Detailed Site Plan Hyattsville Brightseat Road

DSP-15021-01

SUBJECT: Detailed Site Plan DSP-15021-01
 Type 2 Tree Conservation Plan TCP2-026-2015-02
 Hyattsville Brightseat Road

Figure 1: Front Elevation (facing west)

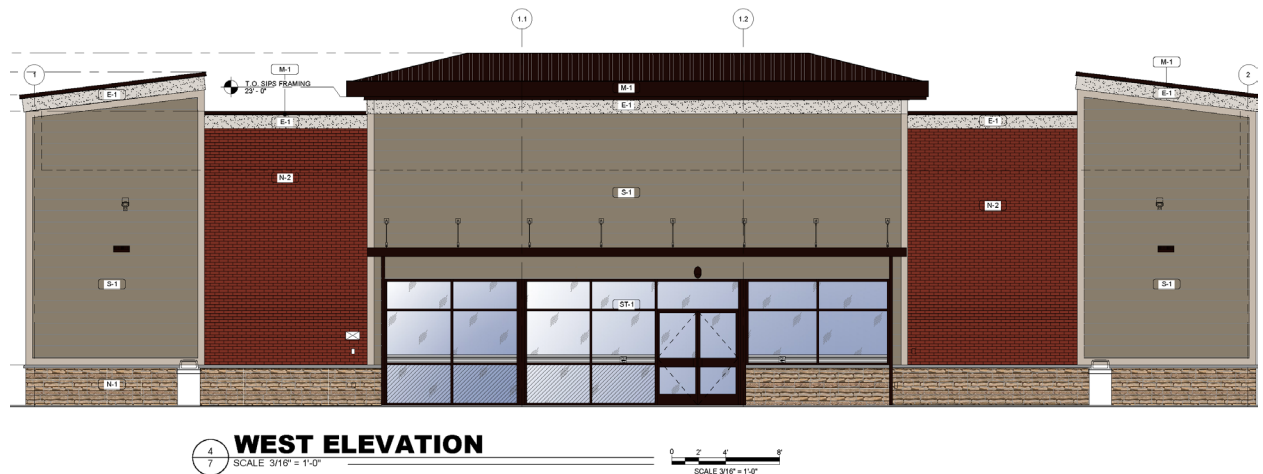
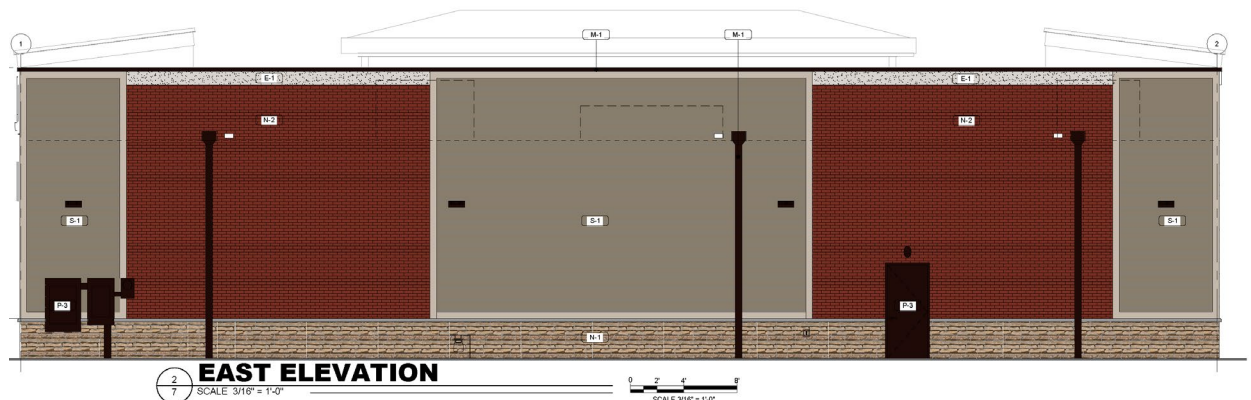
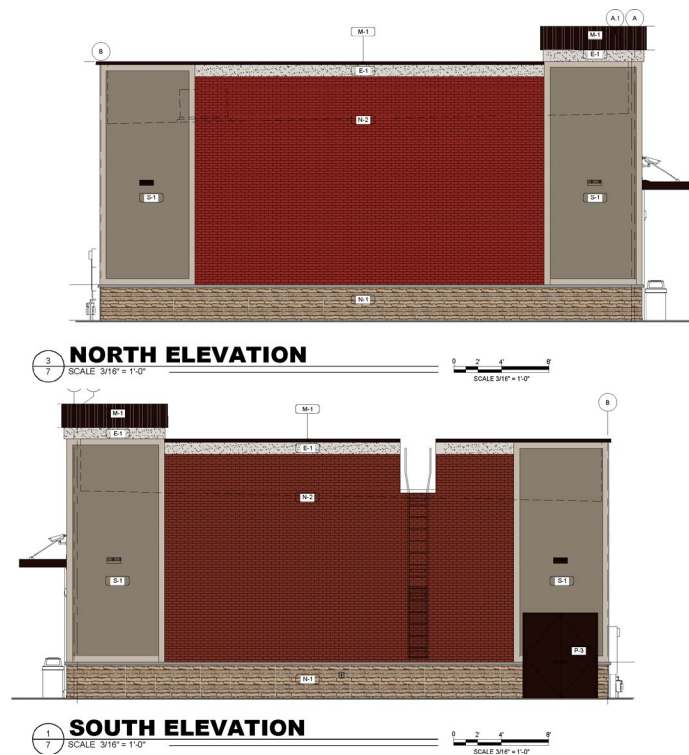
Architectural elevations for the new 7-Eleven store and gas station show a coordinated design theme. The architecture complements the existing architecture of the hotel, located to the east of the site, with the selection of materials, colors, and design elements. Panelized exterior wall systems employing brick, stone, exterior insulation finish system, and composition board (Hardi Plank) of coordinating colors are provided on the store façades. Appropriate fenestration is provided strategically on the main elevations. The colors of both the brick and composite board closely mimic the colors of brick and fiber cement siding used for the existing hotel. The roofline is articulated with sections of pitched roof, complementing the roofline of the existing hotel. The fuel island canopy columns are proposed to be finished with split-face concrete blocks, colored to match the composite board panels on the store façade.

Site details include a retaining wall and a dumpster enclosure. The retaining wall is located along the property's frontage on Brightseat Road, and is proposed to be a poured concrete wall with a maximum height of two feet. Since it will be visible from Brightseat Road, a condition of approval is recommended, to provide a detail to specify the color and building material for the retaining wall. The material should complement the materials used for the convenience store building. The dumpster enclosure uses the same split-face concrete blocks as used for the fuel island canopy columns.

- d. Provide a width dimension for one of the parking spaces located in front of the building.
 - e. Provide a detail for the proposed 2-foot-high retaining wall located next to Brightseat Road, listing the color and building material. The material should complement the materials used for the convenience store building.
